**Re: Review Letter #1**

Russo Acquisitions, LLC  
Preliminary and Final Site Plan  
1000 MacArthur Boulevard  
Block 135.01, Lot 65  
Docket No. 620  
Colliers Engineering & Design Project No. MWP-093

Figure 1: Subject site with property boundaries approximated. Source: Google Maps.

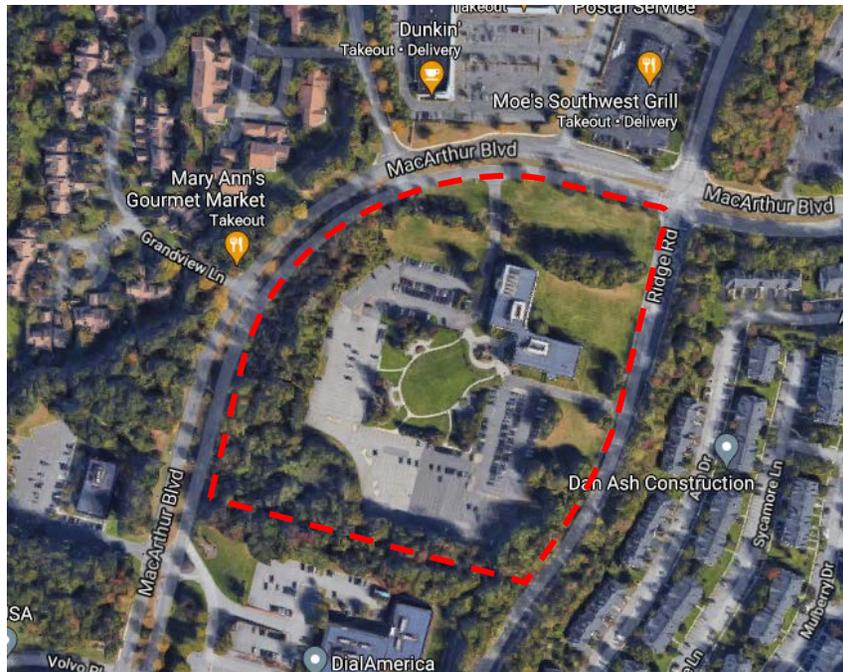
Given the unique shape of this lot, it should be noted that our review of this application is based on the following interpretation of the code for various lot and yards requirements:

- The MacArthur Boulevard frontage serves as the front lot line. This is based on the front lot line definition, which identifies the lot line separating the lot from the street right-of-way. If the lot is bounded by multiple streets or is a corner lot, the front lot line is based on the front yard designated on all maps and official record, or absent such, at the option of the owner or developer. Because the site has been identified in past applications as 1000 MacArthur Boulevard and continues to be addressed as such, our interpretation is that this frontage serves as the front lot line.

- The definitions for rear and side lot line do not specify what to do in the event of a corner lot or triangular-shaped lot. That said, as part of the definition for lot depth, the code states: "In the case of a triangular shaped lot, wherein there is no discernible rear lot line, the lot depth measurement shall be taken from the midpoint of the front lot line to the intersection of the side lot lines where that occurs most distant from the front lot line." Considering that the subject lot is both a corner lot and a semi-triangular lot, it is our interpretation then that the southern lot line and the lot line on Ridge Road serve as side lot lines.

- The lot line along Ridge Road, while identified as a side lot line, is also considered a "side street lot line" according to the code, and as such, is subject to the front yard requirements of Chapter 24 (Zoning).

- Based on the above, our measurement of lot depth is based on the measurement from the front lot line to the intersection of side lot lines, which we have estimated to be approximately 925 feet.

- Similarly, our measurement of lot width is based on the definition in the code for lot width, where width is measured between the side lines from the required front yard setback line. As an oddly shaped lot, the code suggests that the width should also be measured at the front lot line. We have estimated that the lot width at the front lot line to be approximately 1,490 feet, and approximately 1,400 feet from the front yard setback line.
